NOTICE OF BURWOOD LOCAL PLANNING PANEL MEETING

(Item DA5/25) DA.2024.67 - Alterations and additions to the existing dwelling, construction of a new studio and garage on land at No. 23 Chelmsford Avenue, Croydon

(Item DA6/25) Section 4.56 Modification of development application no. DA.2021.88 for a centre-based Child Care Centre (approved by the NSW Land & Environment Court on 10 November 2022).

Figure 2 – Extract of applicant's amended proposed ground floor plan.
Source: (Blu Print Designs)

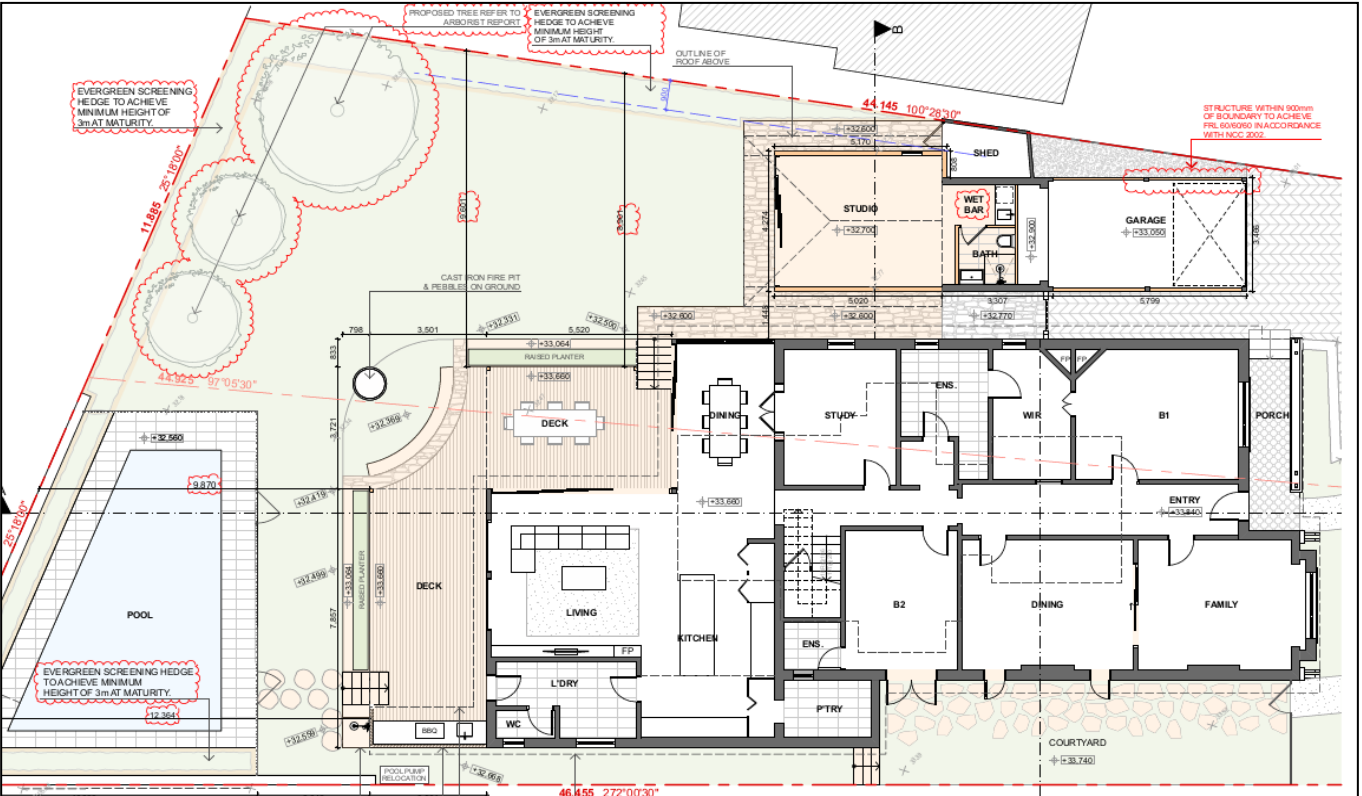
- Ancillary Structures/Garages – Insufficient information was provided on submitted plans to ascertain the height of the garage door, floor to ceiling heights and dimensions of the garage/studio outbuilding structure. The southern elevation of the garage/studio structure has a total wall length of approximately 14.126m and has a setback of less than 900mm from the northern side boundary. The minimum setback from the garage component of the outbuilding structure to the northern side boundary is 200mm, which was not supported.

The proposed studio structure included amenities and cooking facilities which were not supported, and was considered a defacto secondary dwelling. In addition, the roof plan indicated that the garage roof projected over the adjoining property boundary, which was not supported.

Figure 14 – Extract of the applicants submitted proposed ground floor plan indicating the bathroom within the proposed studio, to be accessed via an externally accessed door only.

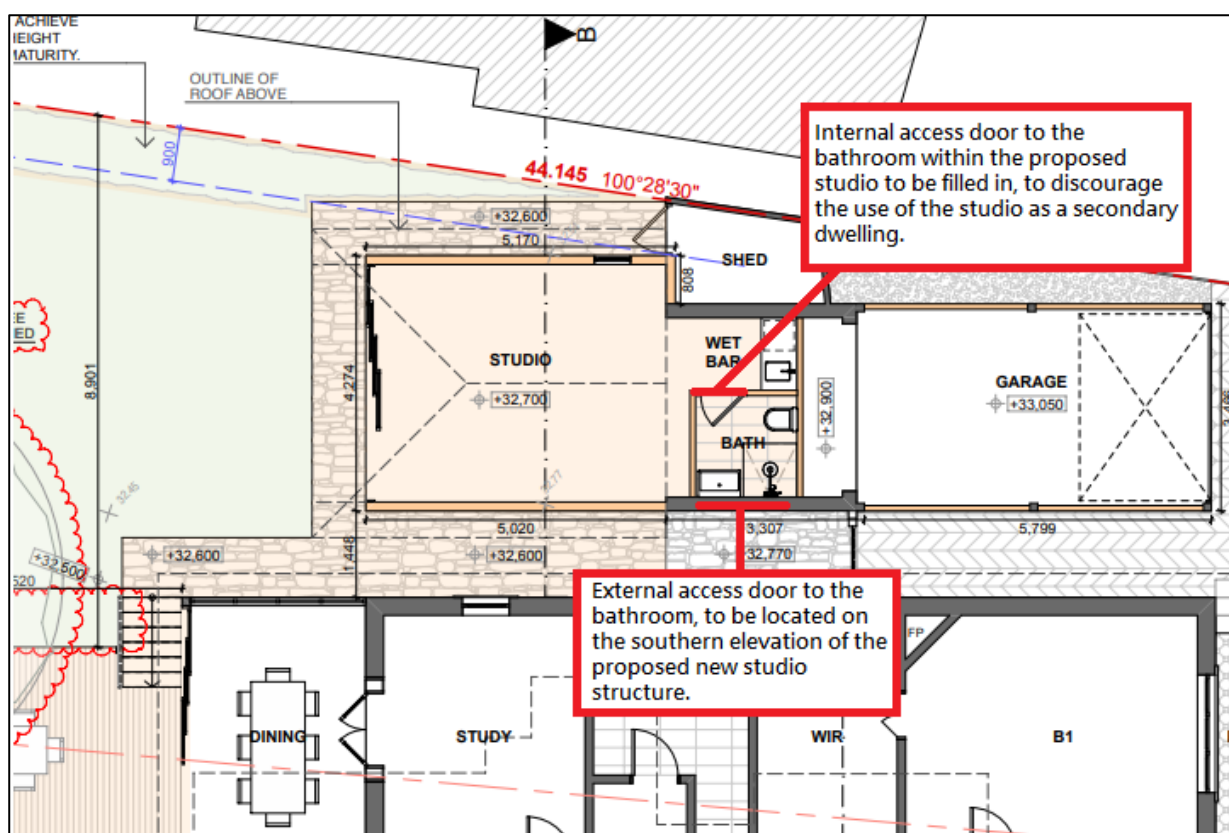
In order to discourage the use of the proposed studio structure as a secondary dwelling, the following condition is imposed:

1. The bathroom within the proposed studio is to be accessed via an externally-accessed door only. No cooking facilities are to be installed within the studio structure. Details of the method of complying with this requirement must be noted on the plans or in the specifications **prior to the issuing of a Construction Certificate**. (Refer to **Figure 14** below).

Approved DA Plans Site Plan (Extract) – Showing the notation stating existing substation to be relocated, the current approved position of the new substation.

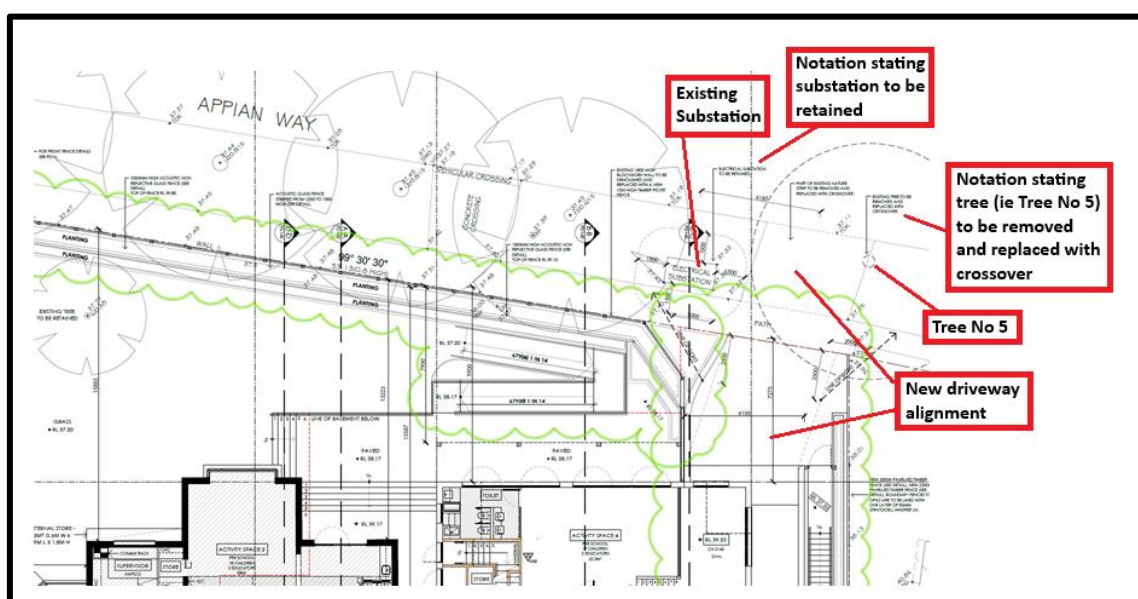
One of the central issues of the modifications relates to the retention of an existing electrical substation (in Appian Way) in its current location, instead of relocating it to the south-western corner of the site (as per the originally approved DA plans). The applicant has identified several issues and reasons why it is preferable to retain the substation in its current location.

The applicant has proposed that the modified driveway location in response to retaining the existing substation would require removal of Tree No 5 (which is a *Lophostemon confertus* "Brush Box). To support their request for removal, the applicant has stated that allowing the substation to remain in its location would prevent removal of 2 other trees (No 10 and 14) that would be associated with the current approved location of the substation (ie on the south-western side of the site).

Further, there is no evidence submitted to indicate that the new position of the substation (as per the current approval, see Approved Plan extract above) would result in removal of Tree No 10 and No 14 as stated by the applicant.
